2016/SDD-23(EK)

Subject: Application for an Interim Planned Development-Transit (IPD-T)
and Special District Permit Application No. 2016/SDD-23
Project: Manaolana Place Hotel and Residential
Condominium Development Project
Landowners: Manaolana Partners, LLC
Kaijima Kagaku USA Inc.
Applicant: Manaolana Partners, LLC
Agent: Kusao & Kurahashi, Inc. (Keith Kurahashi)
Location: 1685, 1687, 1689, 1691, and 1695 Kapiolani Boulevard,
508 and 512 Atkinson Drive
1674 and 1676 Kona Street – Kalia, Waikiki
Tax Map Keys: 2-3-41: 1 and 2
Acceptance Date: April 5, 2016

FINDINGS OF FACT, CONCLUSIONS OF LAW
AND RECOMMENDATION

EXHIBIT C-1

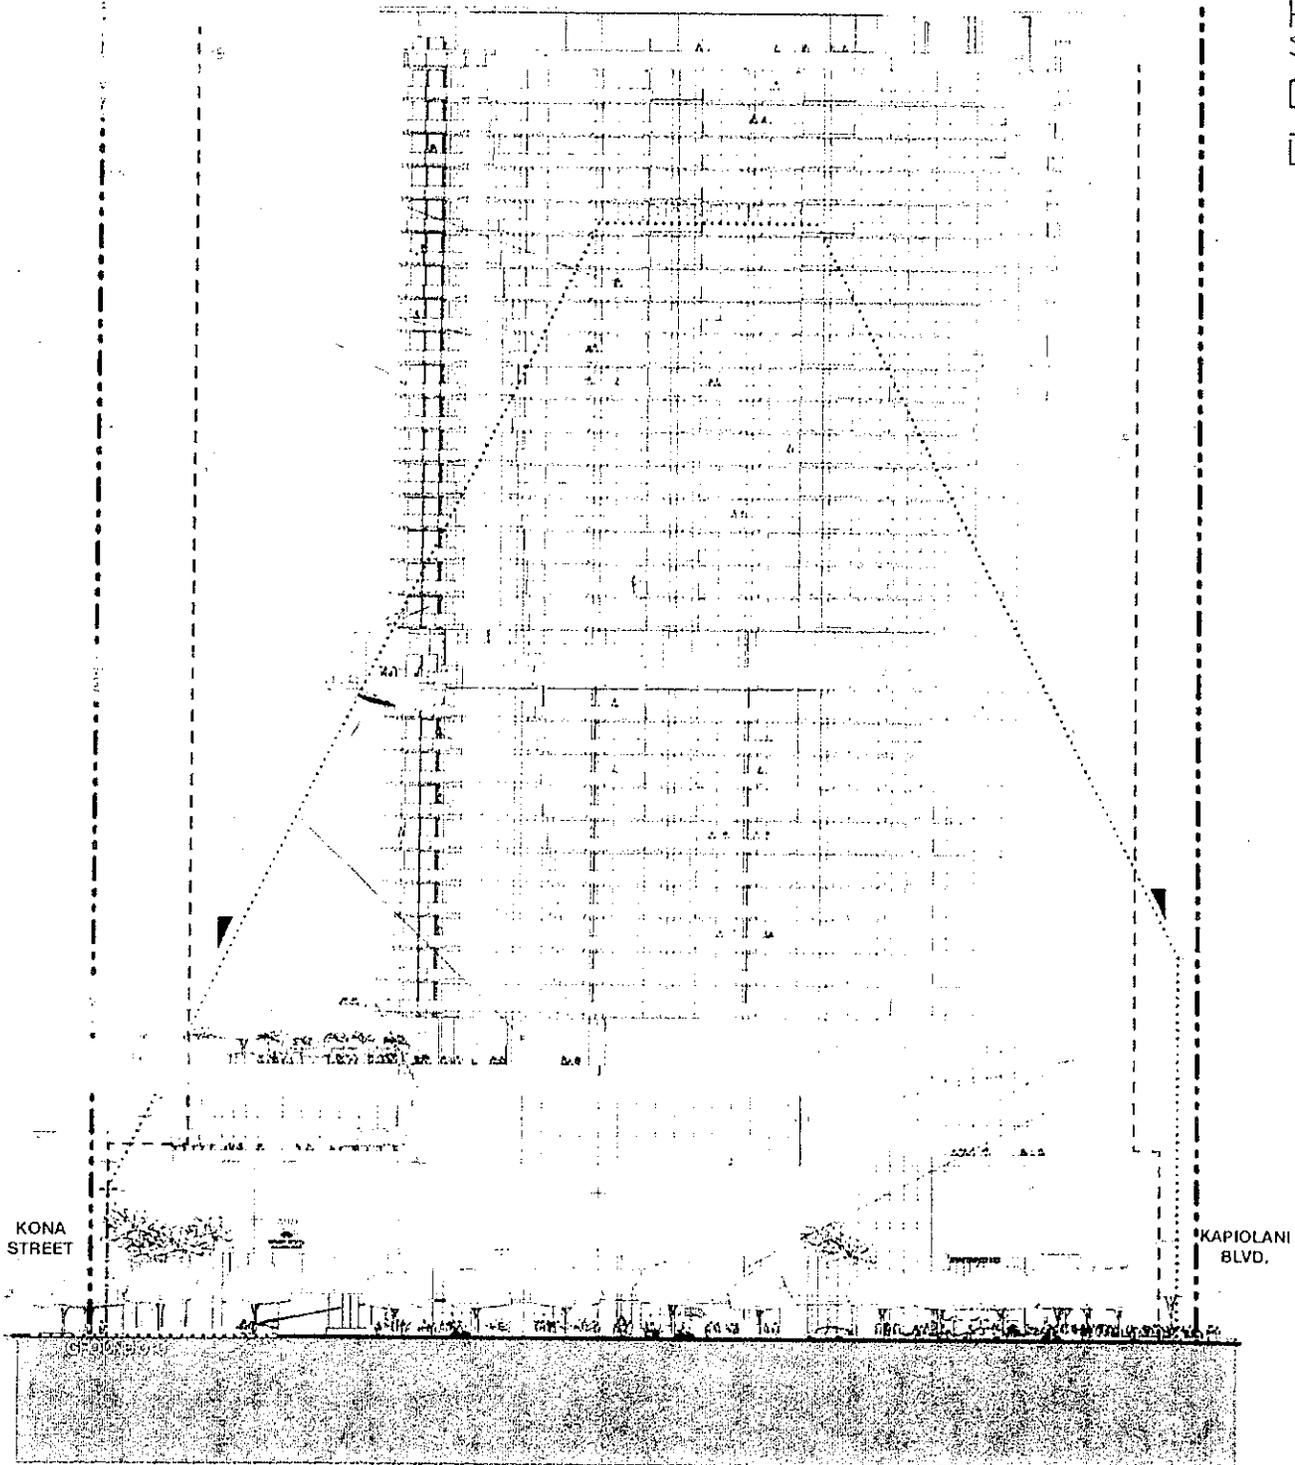
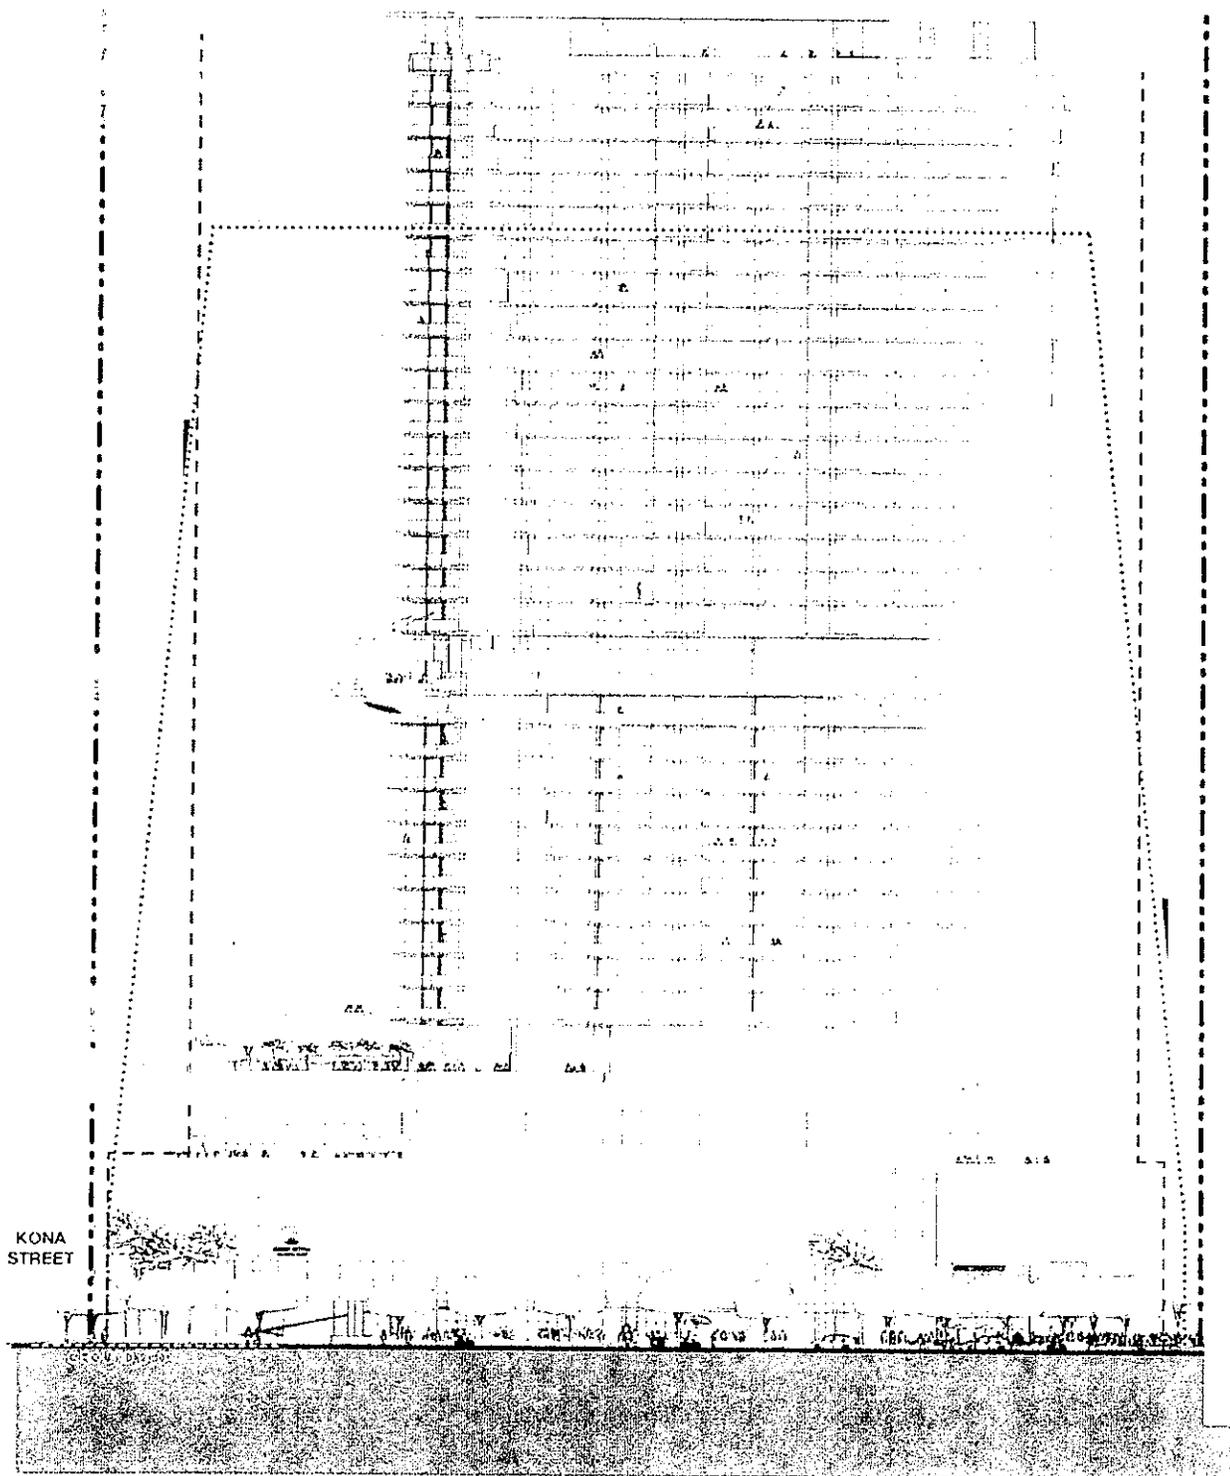
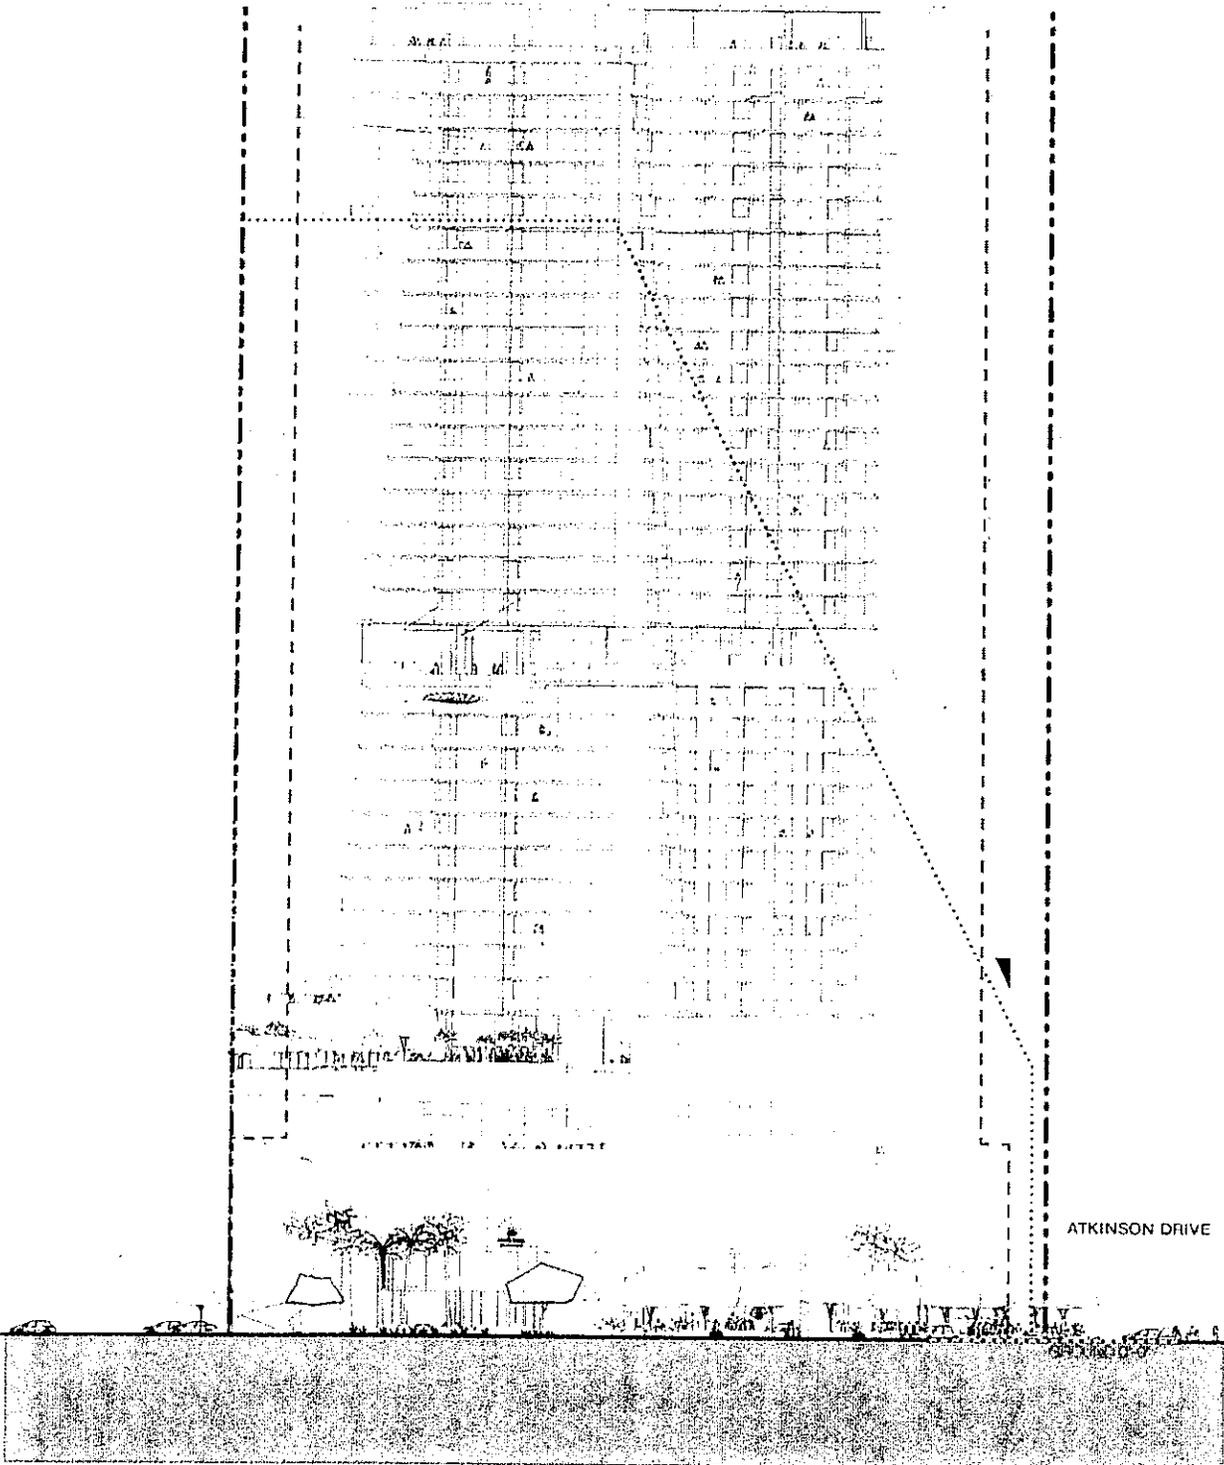
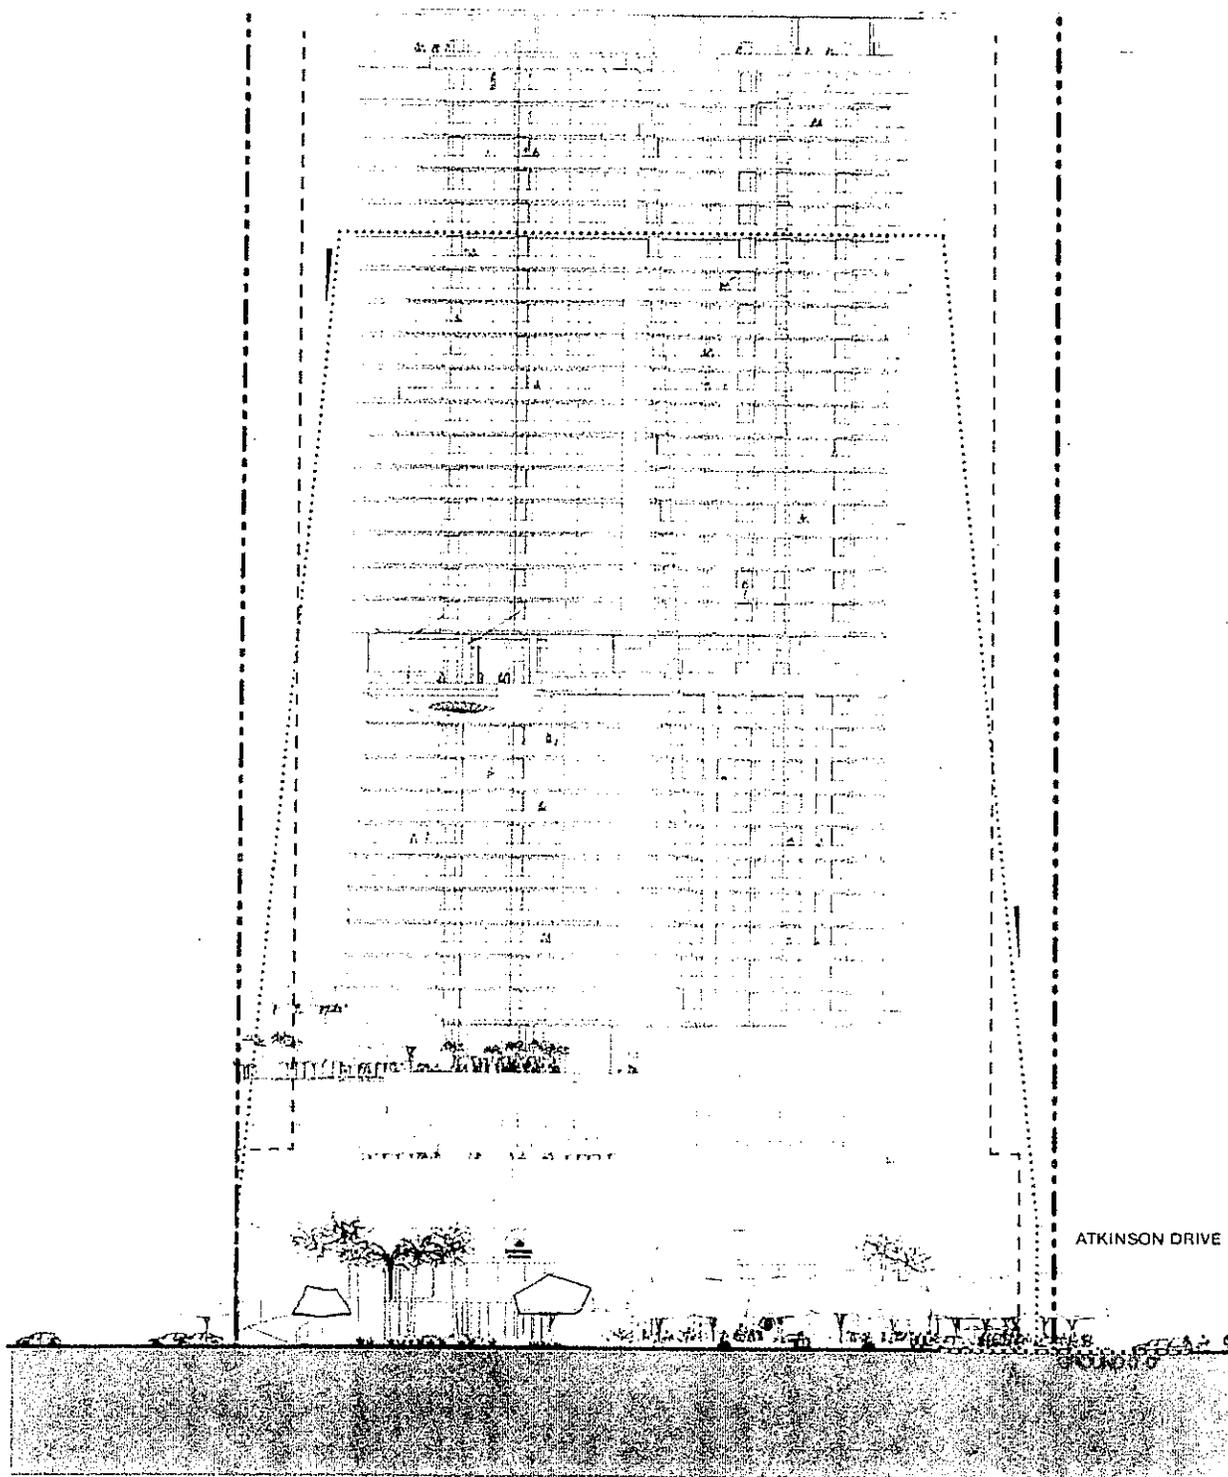
2. Height: The maximum height limit for the site is 350 feet. The IPD-T provisions allow a maximum height limit of 400 feet, as specified in the TOD Neighborhood Plan. According to the application documents, the Applicant is requesting to exceed the height limit by 50 feet for a maximum height of 400 feet. However, the elevation plans show the new tower with a height of 418 feet (Exhibits C1 through C-7).

In accordance with LUO Section 21-4.60(c)(1), the Director may exempt necessary mechanical appurtenances, and utilitarian and architectural features from the height regulations of the LUO, provided they are erected only to such height as is necessary to accomplish the purpose they serve, but in no case exceeding 18 feet above the maximum height limit for roof forms. The plans currently label the rooftop terrace as the 37th floor and show a large rooftop level that exceeds 400 feet. The portion of the rooftop above 400 feet cannot be considered necessary mechanical equipment and therefore shall not be allowed in its current format. Therefore, if permitted to increase the height limit to 400 feet, the Applicant must modify the plans to comply with the height limit. This should be required as a condition of approval.

5. **General consistency with the Ala Moana Neighborhood TOD Plan, Draft Final Plan, dated April 2016.** The Project is generally compliant with the TOD Plan. The DPP TOD Division commented that the proposed Project is consistent with the TOD Plan and City policies directing compact, mixed-use high-density development within the transit rail corridor, and consistent with the height, density, and design recommendations of the TOD Plan. The proposal is generally consistent with the setbacks recommended in the TOD Plan, which specifies that above 60 feet in elevation, the tower should be set back 20 feet from the property line (Exhibits C-1 through C-7).

- B. The maximum height of the Project shall be 400 feet.
- C. The height setback shall be as follows: Any portion of a structure over 40 feet in height shall have additional height setbacks; for each 10 feet of additional height or portion thereof, an additional one-foot setback shall be provided. The additional setback shall be a continuous plane from the top of the structure to the height of 40 feet above grade.
